CHANGE LIST

Model  
CT3/5 MB BOARD

CT3/5 MB  
31CT3MB0015  
31CT3MB0031

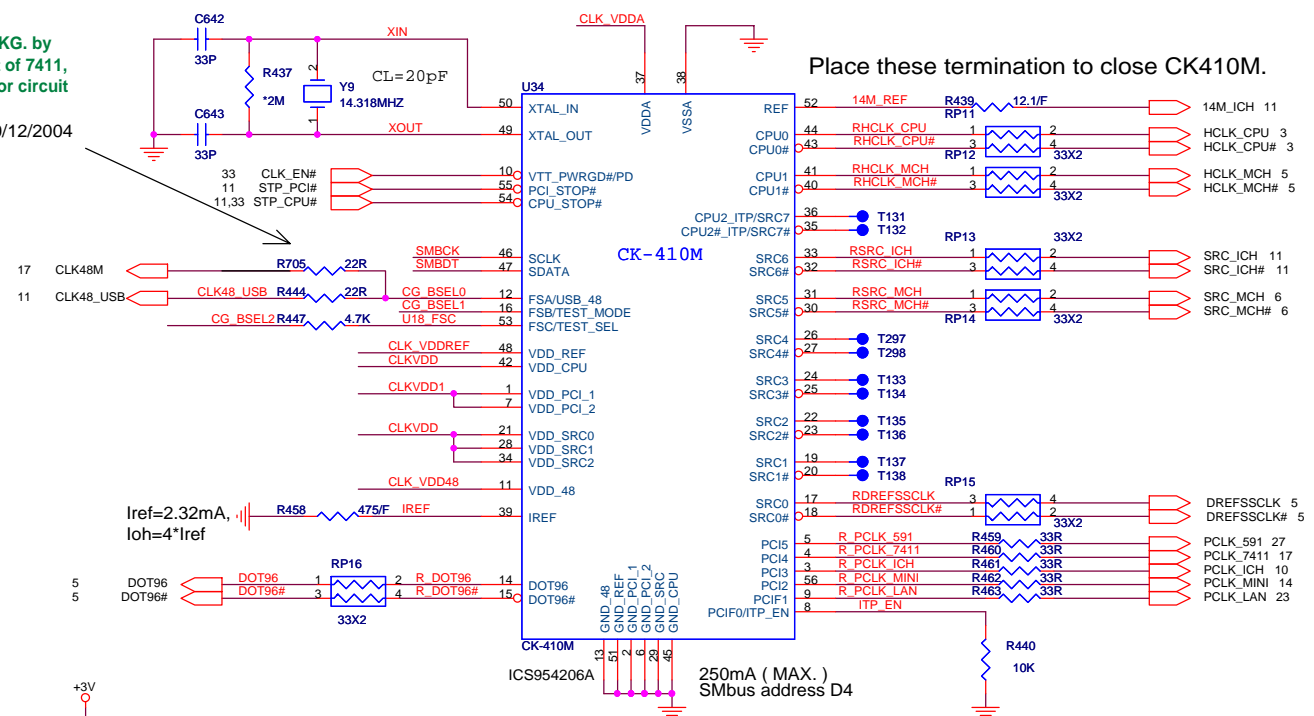
SI stage:  
 Enable CLK48M from CKG. by  
 R705 for the PLL circuit of 7411,  
 and disable the oscillator circuit  
 at PCI7411 side.

PV stage:  
 Add C1048 for CLK48M to get better EMI  
 performance.

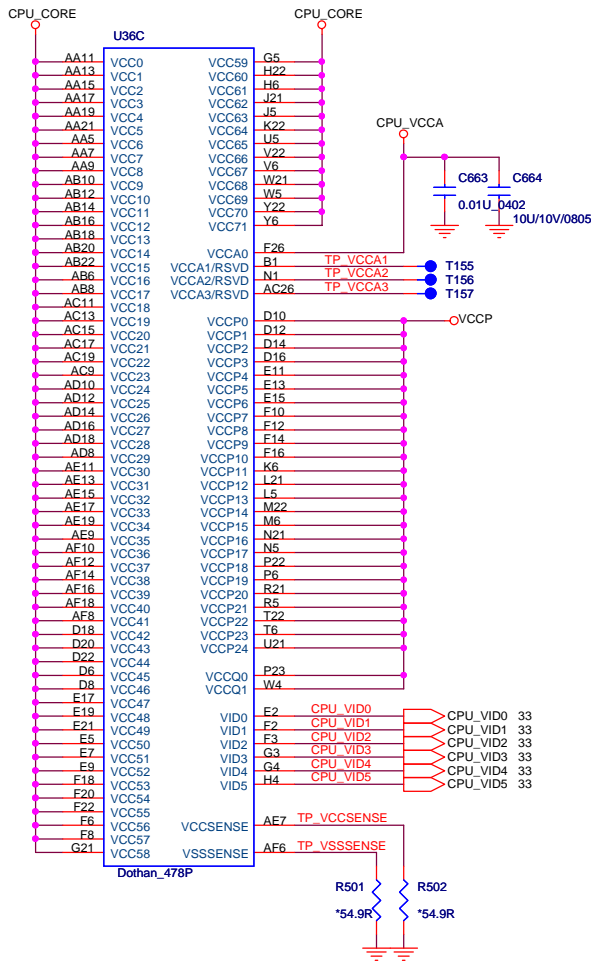
SI stage:  
Remove H/W shutdown circuit  
(R613&Q54)that supported  
ADM1032.  
Sting 10/12/2004

PV stage:  
Add R733 as pull-up resistor for PREQ#.  
Sting 11/29/2004

Size	Document Number	Rev
Customer	<b>CPU POWER / GND</b>	2A
Date:	Monday, December 27, 2004	Sheet 4 of 39

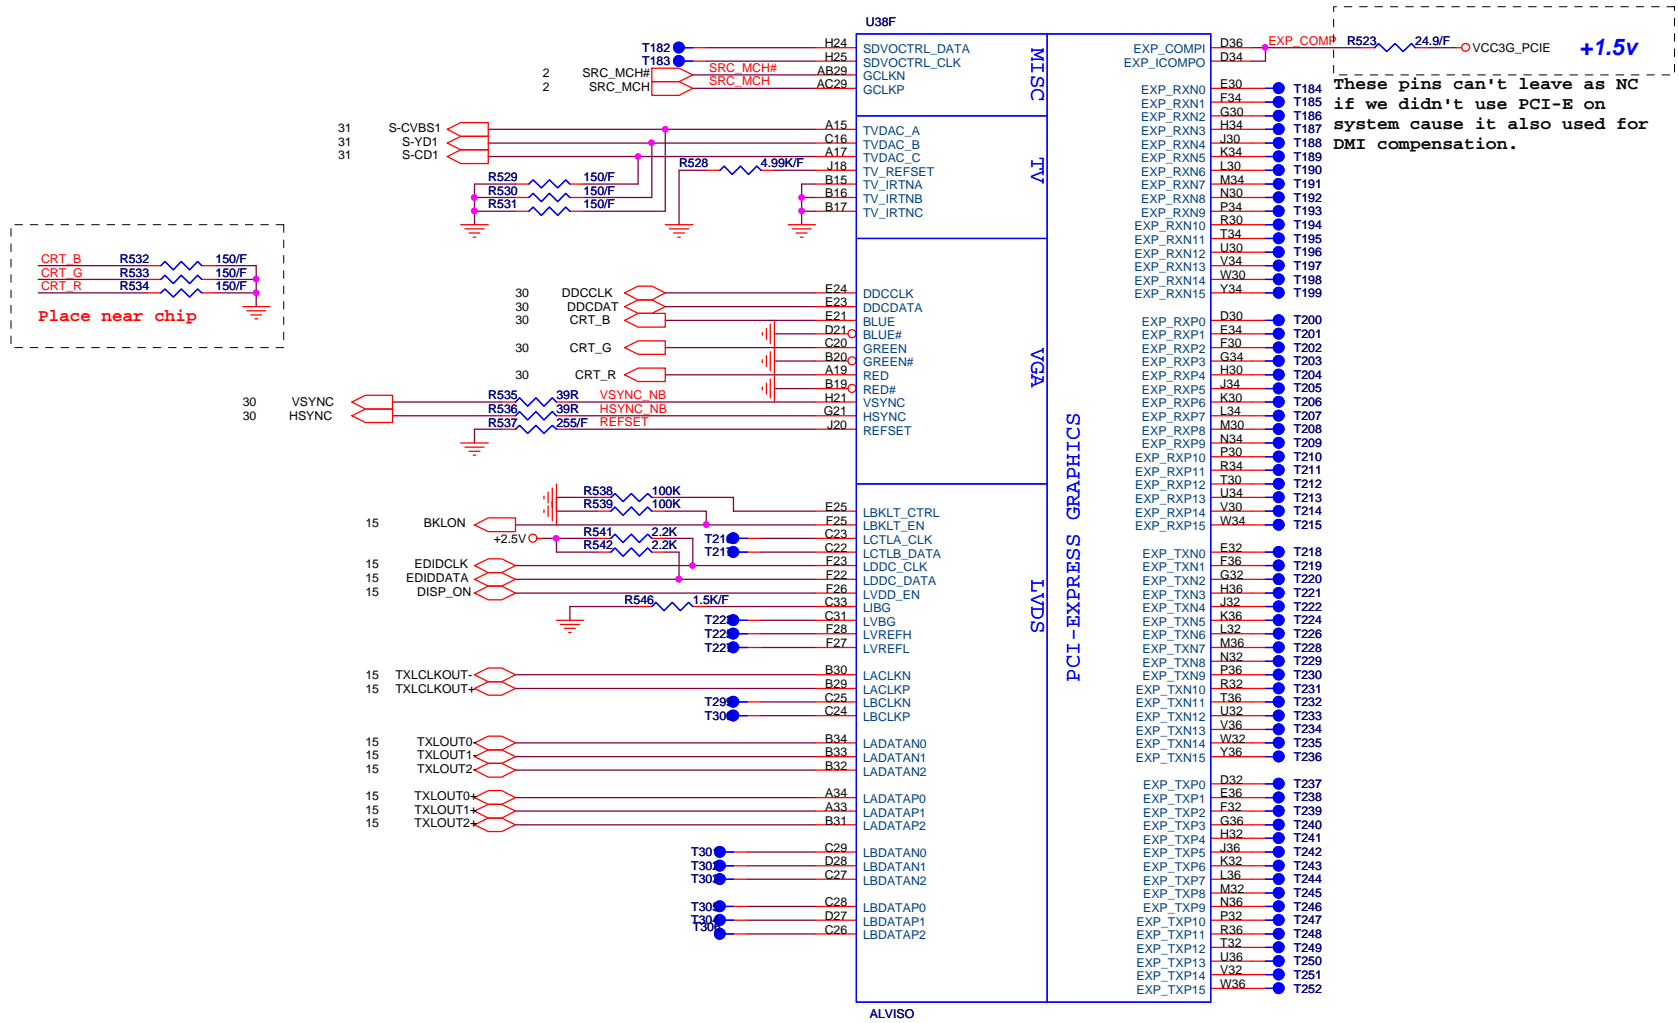
SI stage:  
Use X7R type to replace Y5V type for Decoupling/Bypass capacitor.  
Sting 10/12/2004

Size	Document Number	Rev
Custpm	ICH6-M (USB/HUB/LPC)	2A
Date:	Monday, December 27, 2004	Sheet 11 of 39

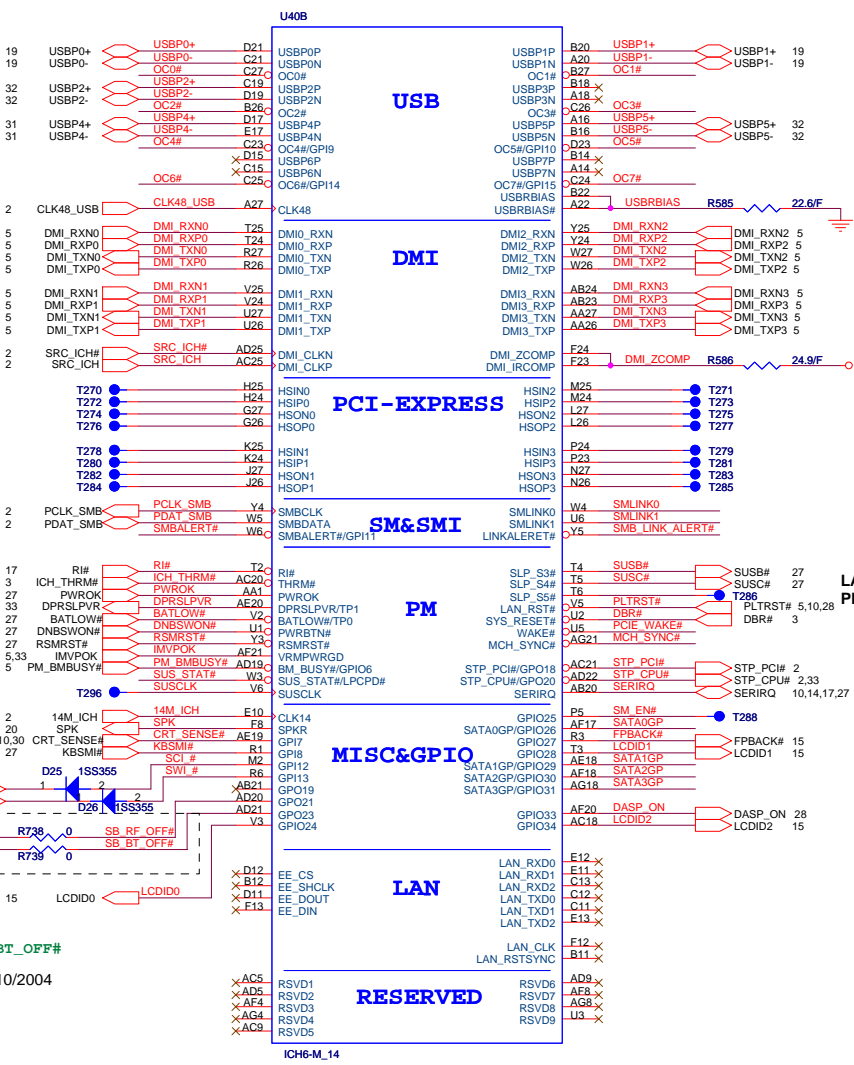
SI stage: R589 should be populated, because MCH\_SYNC# is internally ANDed with PWROK. System will not booting without this pulled-up resistor.

1. Change the power plane of PCIE\_WAKE# from 3VSUS to 3V\_S5 to solve system can't turn off issue.
2. Change the power plane of ICH\_THRM# and SCI\_# from 3VSUS to +3V to solve leakage issue.

PV stage: 1. Add RF\_OFF# and BT\_OFF# circuit.

Size	Document Number	Rev
Custom	ICH6-M (POWER)	2A
Date:	Monday, December 27, 2004	Sheet 12 of 39

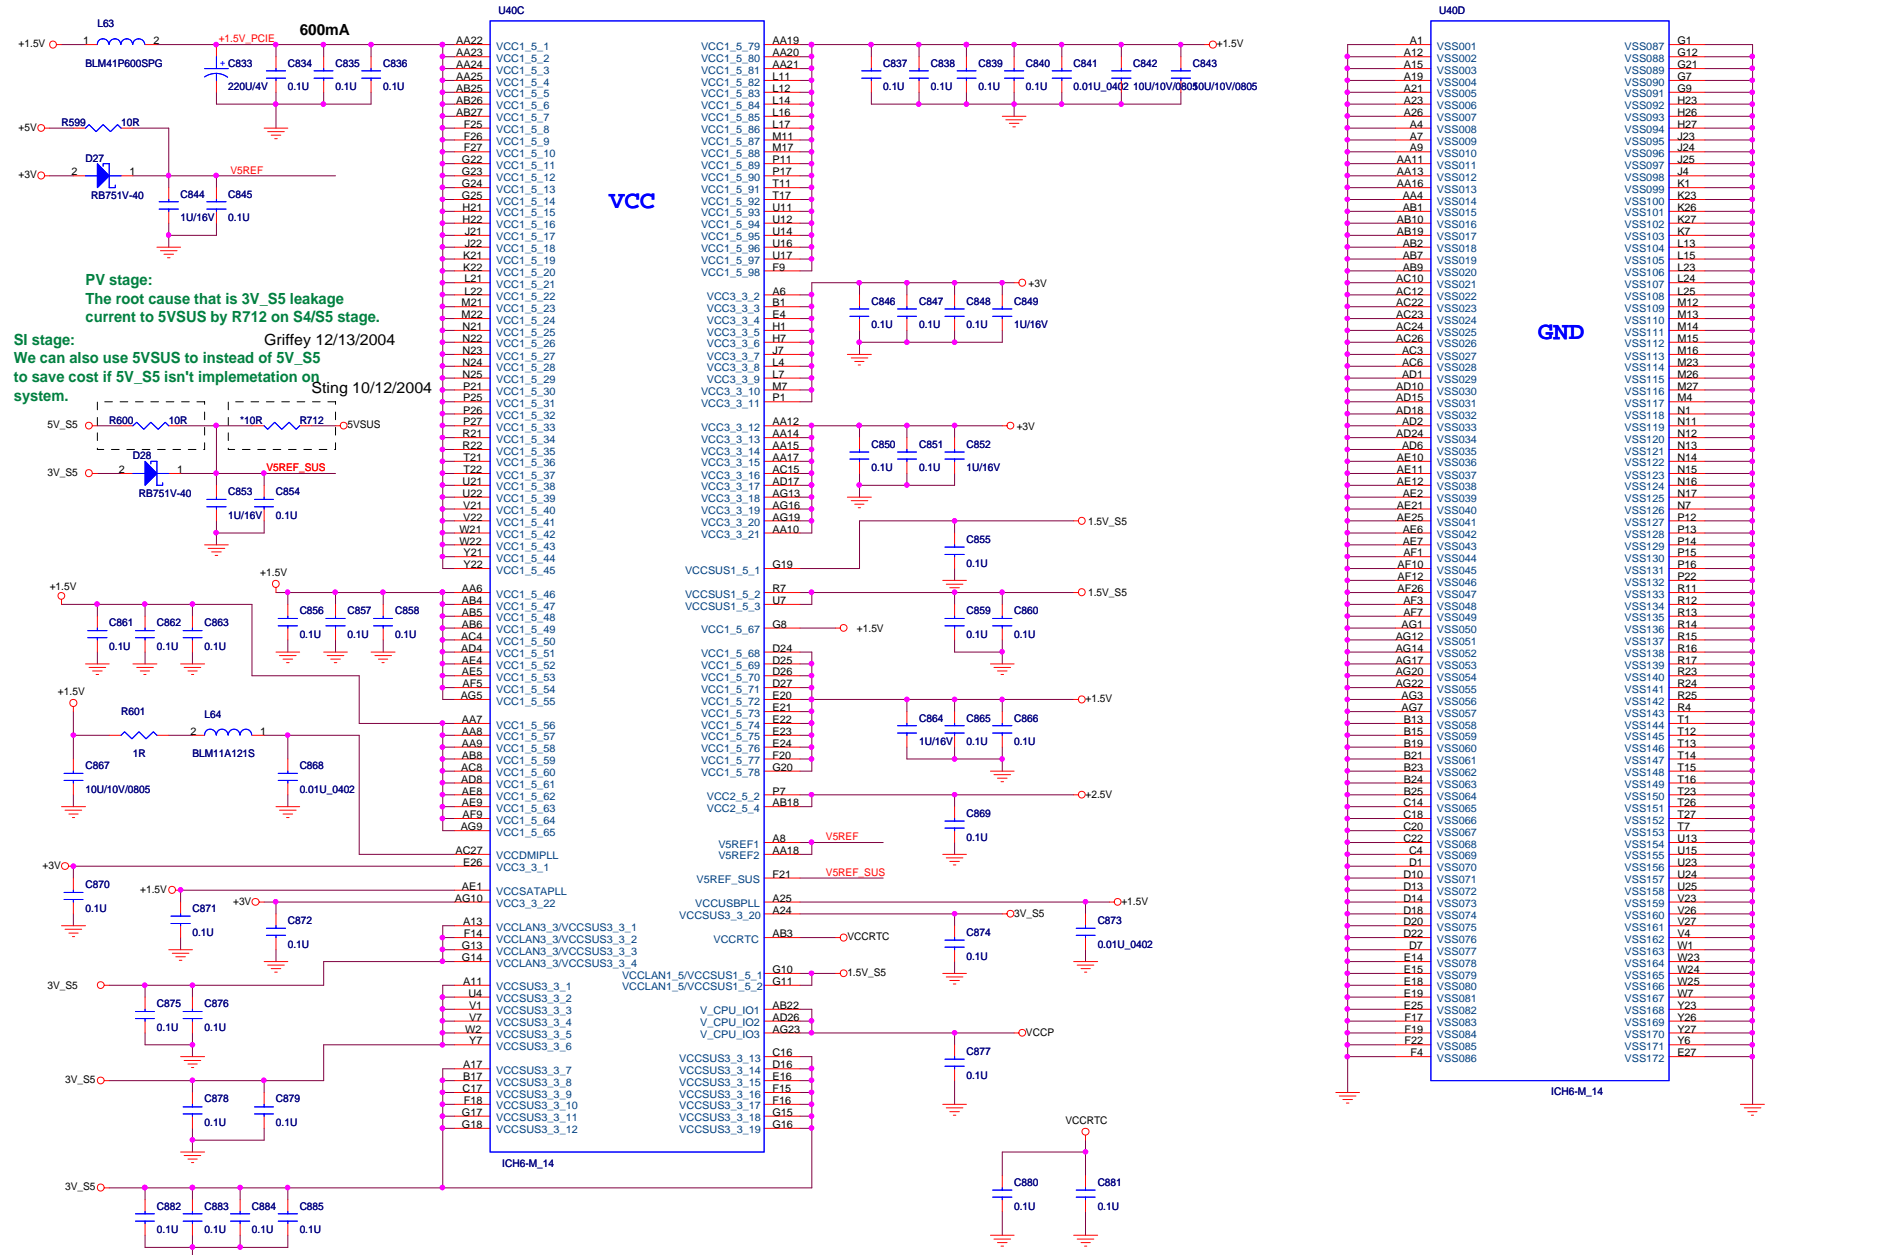
**PV stage:**  
 The root cause that is 3V\_S5 leakage current to 5VSUS by R712 on S4/S5 stage.

**SI stage:**  
 We can also use 5VSUS to instead of 5V\_S5 to save cost if 5V\_S5 isn't implementation on system.

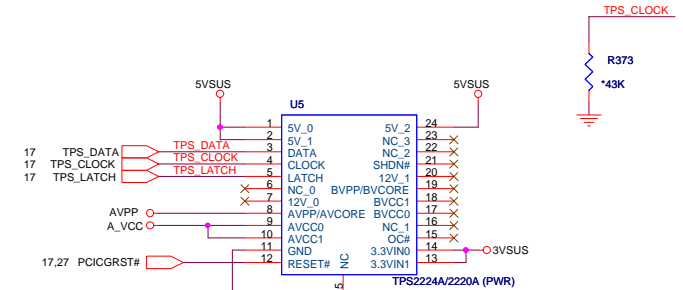
PV stage:  
Remove unused PCI1510RVGF circuit.

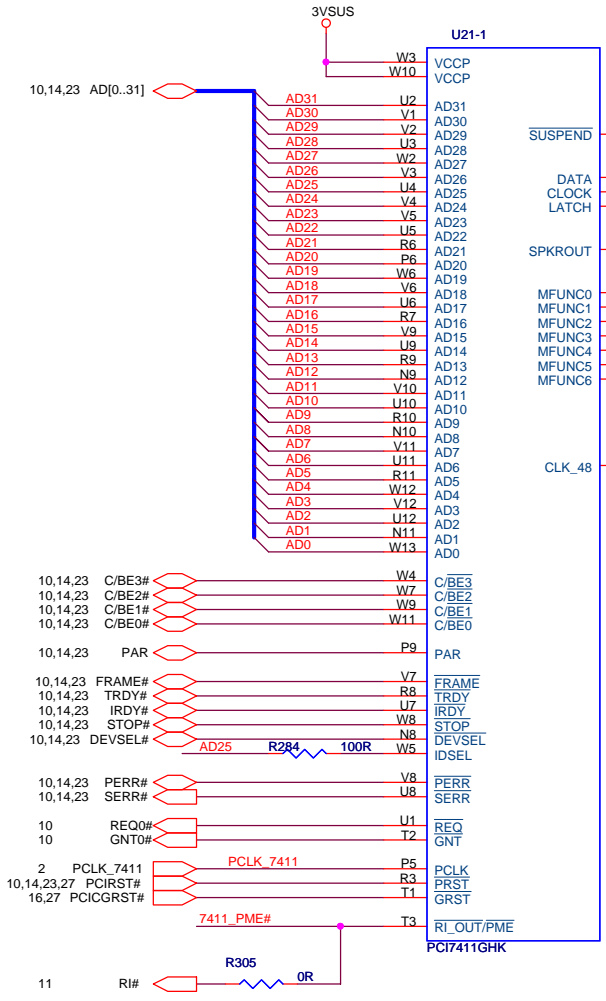
SI stage:  
Remove all component of PLL circuit and Add  
CLK48M input from CKG.

PV stage:  
Populate R704 and C1045 for getting better  
EMI performance.  
Sting 11/19/2004

# CARD POWER CONTROL

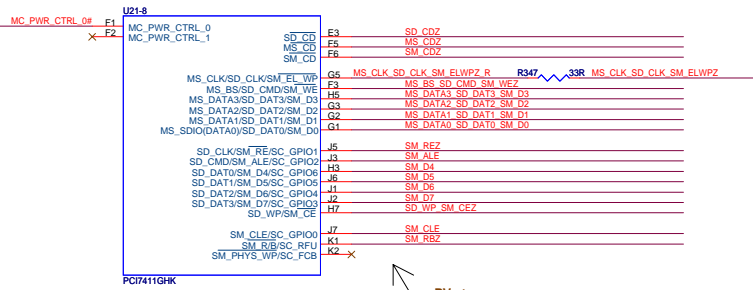
PV stage:  
Add a discharge circuit for media  
card power.  
Sting 11/19/2004

PV stage:  
1. Disconnect SM\_PHYS\_WP.  
2. Tie SM\_EL\_WP with SM\_PHYS\_WP of SM card to allow  
for normal operation of SD and SM.  
Sting 11/19/2004

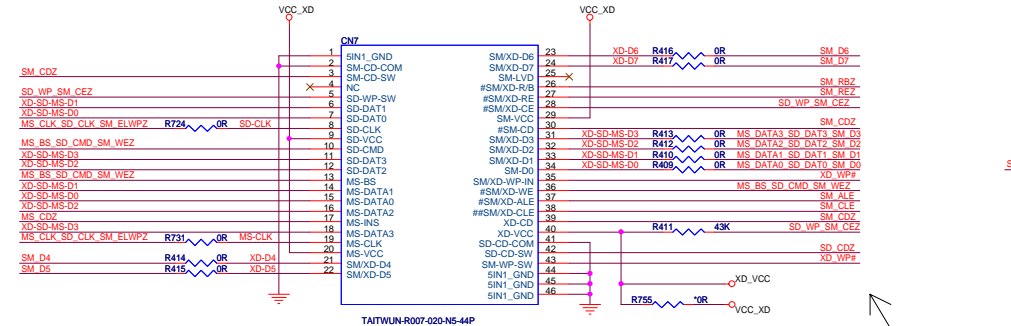
PV stage:  
1. Add quick switch circuit.  
Griffey 12/10/2004

PV stage:  
1. Add pull-up circuit.  
Griffey 12/20/2004

PV stage:  
1. Add R717 to solve SM card can't write protect issue.  
2. Add R718 to solve cross-talk issue of MS-PRO card.  
3. Add R719-R736 as terminal on all multi-funton pin.  
Sting 11/19/2004

## IEEE 1394 CONNECTOR

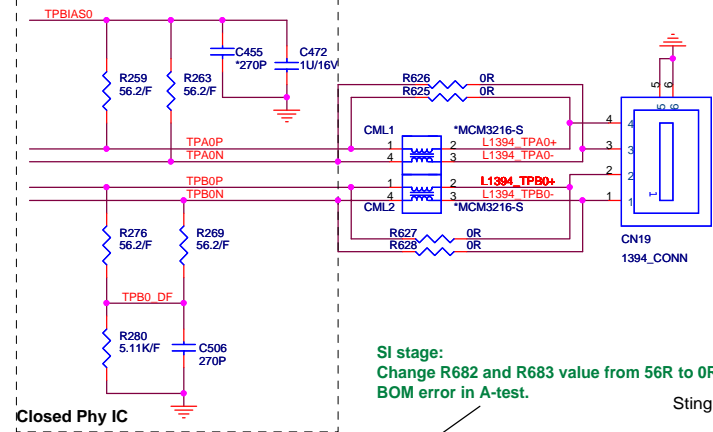
SI stage:  
Change R682 and R683 value from 56R to 0R cause of BOM error in A-test.
